2nd Further Information

**Proposed Temporary Warehouse (Excluding Dangerous Goods Godown) with Ancillary Facilities
and Associated Filling of Land for a Period of 3 Years in "Agriculture" Zone,
Various Lots in D.D. 107, Fung Kat Heung, Kam Tin North, Yuen Long, New Territories**

(S.16 Planning Application No. A/YL-KTN/1266)

Responses-to-Comments

DWG. TITLE
FILLING OF LAND AREA

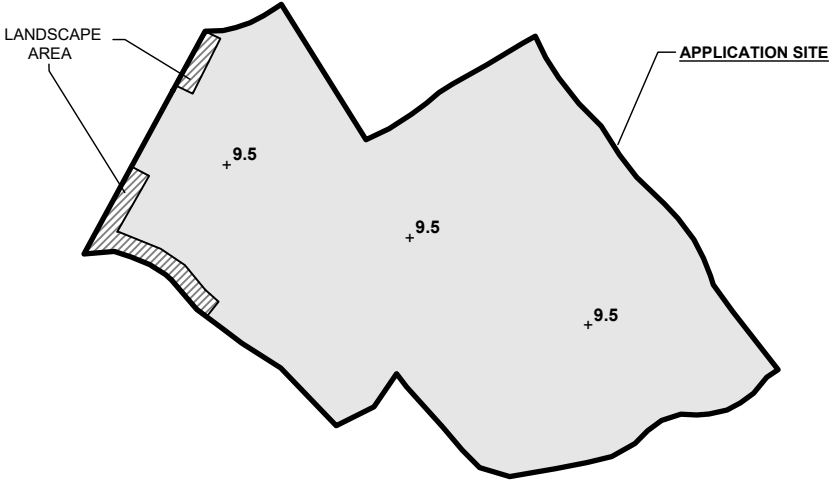
(1)	I must point out that the following irregularities covered by the subject planning application have been detected by the office: <u>Unauthorised structure(s) within the said private lot(s) covered by the planning application</u> LandsD has reservation on the planning application since there is/are unauthorised structure(s) and/or uses on Lot Nos. 913 RP and 958 in D.D. 107 which is/are already subject to lease enforcement actions according to case priority. The lot	Noted. The applicant will apply for modification of Short Term Waiver (STW), as well as to liaise with relevant land owners for a STW application to rectify the applied use on the application site (the Site) after planning permission has been granted from the Board. No structure is proposed for domestic use.

owner(s) should immediately rectify/apply for regularization on the lease breaches as demanded by LandsD. If the planning application is approved, the STW holder(s) will need to apply to this office for modification of the STW conditions where appropriate, and the lot owner(s) without STW shall apply to this office for a STW to permit the structure(s) erected within the said private lots. The application for STW will be considered by the Government in its capacity as a landlord and there is no guarantee that it will be approved. The STW, if approved, will be on whole lot basis and subject to such terms and conditions including the payment of waiver fee, rent and administrative fee as considered appropriate by LandsD. Besides, given the proposed use is temporary in nature, only erection of temporary structure(s) will be considered.	
--	--	--

PART OF THE EXISTING HARD-PAVING WILL BE REMOVED BY THE APPLICANT (ABOUT 71 m²) FOR THE USE OF LANDSCAPE AREA. NO FURTHER FILLING OF LAND WILL BE MADE BY THE APPLICANT AFTER PLANNING PERMISSION HAS BEEN OBTAINED FROM THE TOWN PLANNING BOARD.

LANDSCAPE PROPOSAL

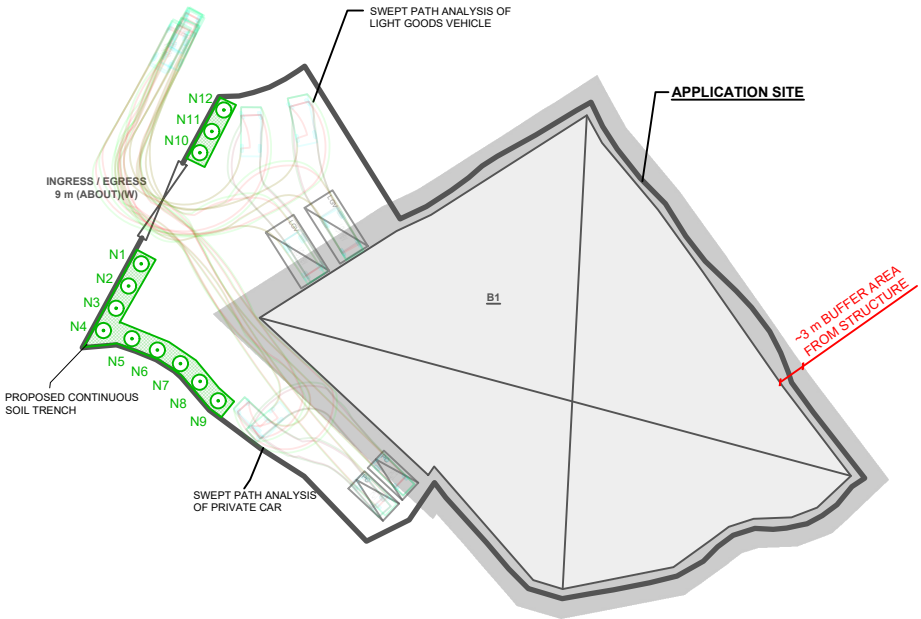
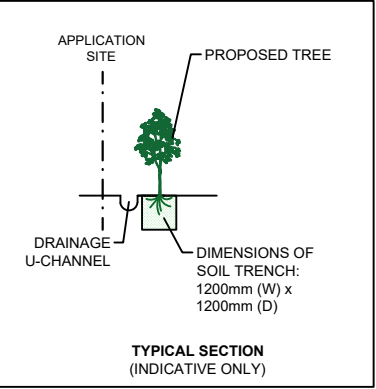
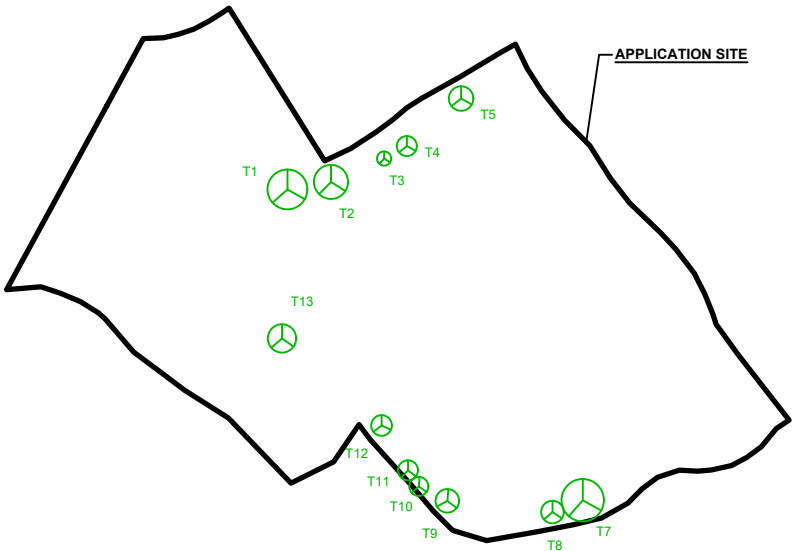
- (i) This application is the subject of a previous application (No. A/YL-KTN/1031). During the previous application period, the application site (the Site) was hard-paved for the erection of structures, provision of parking and loading/unloading (L/UL) spaces and circulation spaces, which is considered necessary for the applicant’s operational need. Thus, all trees within the Site have already been felled.

- (ii) To compensate for the tree loss, the applicant proposed to plant 12 new trees with continuous soil trench along the west and northwest periphery boundary of the Site under the current application period (**Appendix III**). The trees can act as a landscape buffer to minimise adverse visual impact to the surrounding areas. In addition, all these new trees within the Site will be maintained by the applicant during the planning approval period. Revised land filling plan and landscape proposal are also enclosed for Government department’s consideration (**Appendices II and III**). For information, the submitted landscape proposal (**Appendix III**) has took forward of the approved landscape proposal of the previous application No. A/YL-KTN/1031; and
